**STAFF RECOMMENDATION**  
**2011 18<sup>th</sup> Avenue South**  
**February 15, 2017**

**Application:** New construction—outbuilding; Setback determination  
**District:** Belmont Hillsboro Neighborhood Conservation Zoning Overlay  
**Council District:** 18  
**Map and Parcel Number:** 10412021600  
**Applicant:** Zach Provonchee, Architect  
**Project Lead:** Sean Alexander, sean.alexander@nashville.gov

<p><b>Description of Project:</b> Application is to construct an outbuilding at the rear of the lot. The structure requires a rear setback determination from ten feet (10') to six feet, six inches (6'-6"). The building will not be used as a dwelling unit.</p> <p><b>Recommendation Summary:</b> Staff recommends approval of the outbuilding with the condition that the metal roof color and the window and door selections shall be approved by MHZC prior to purchase. With that condition, staff finds that the outbuilding meets section II.B.1.i of the design guidelines for the Belmont-Hillsboro Neighborhood Conservation Zoning Overlay.</p> <p>The Commission does not have the authority to approve the use. This recommendation is for the design of the building based on the proposed use.</p>

1 site plan  
 1/8" 0 4 8 16'

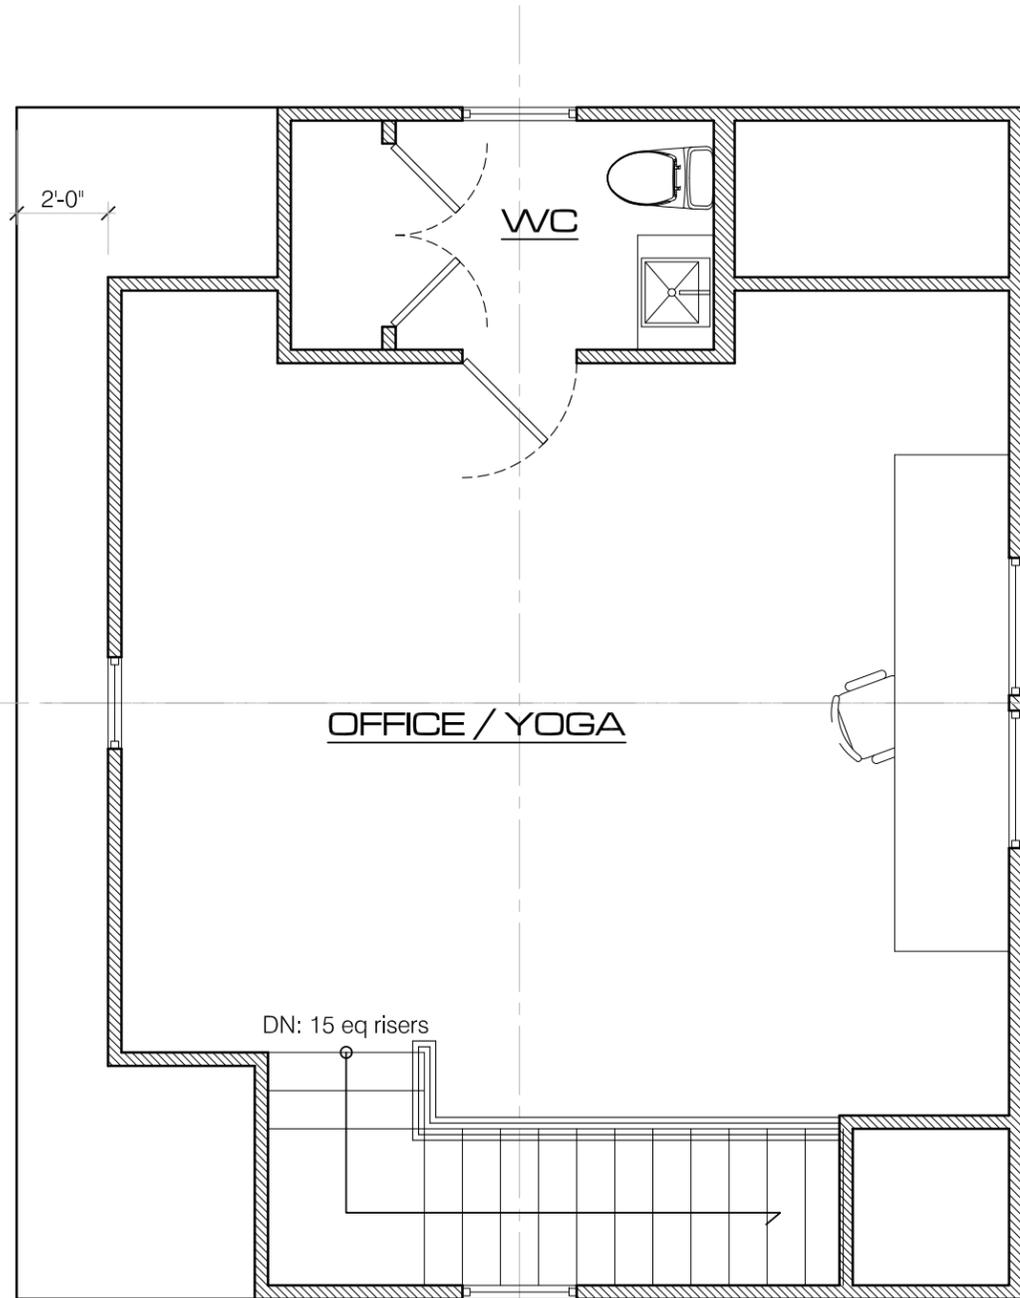
The applicant proposes to locate the building at the rear of the lot, with a rear setback of six feet, six inches (6'-6"). This location is typical of outbuildings historically, but is shorter than the standard setback requirement of ten feet (10'). The shorter setback also allows for more space between the outbuilding and the principal building, which is already constrained on a lot that is shallower than most of the lots nearby. Staff finds that the project meets sections II.B.1.c and II.B.1.h of the design guidelines with the rear setback proposed.

**Recommendation:** Staff recommends approval of the outbuilding with the condition that the metal roof color and the window and door selections shall be approved by MHZC prior to purchase. With that condition, staff finds that the outbuilding meets section II.B.1.i of the design guidelines for the Belmont-Hillsboro Neighborhood Conservation Zoning Overlay.
